Soorty Textiles (BD) Ltd

Plot # 220-227, Comilla EPZ, Old Airport Area, Comilla 3500

17 March 2015

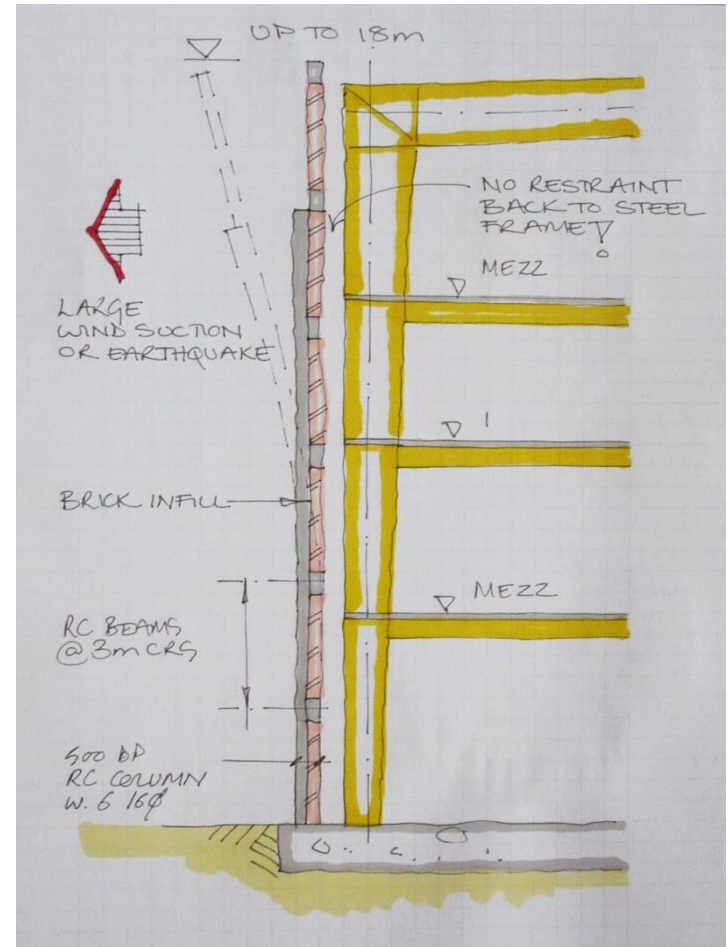
**Façade wall appears to require
additional restraint**

The façade wall appears to be unrestrained, i.e. it is an 18 m high free standing wall. Without restraint the wall may collapse in strong wind or in an earthquake.
 1. Concrete/masonry wall 2. Gap with polystyrene void former between steel and concrete column 3&4. Cracks between steel and concrete column after plastering

Item No.	Observation	Recommended Action Plan	Recommended Timeline
1	Façade wall appears to require additional restraint	Structural Engineer to check lateral stability of façade wall for wind suction and earthquake loads.	6-weeks
2	Façade wall appears to require additional restraint	Implement any remedial measures recommended by the Structural Engineer and ensure that these are co-ordinated with the steel frame designer.	6-months
3	Check stability of portal frame compression flanges	Steel Frame Designer to review the lateral stability of portal frames paying particular attention to: 1 – effective length of columns 2 – connection loadpath between brace and portal frame	6-weeks
4	Check stability of portal frame compression flanges	Implement any remedial measures recommended by the Steel Frame Designer.	6-months
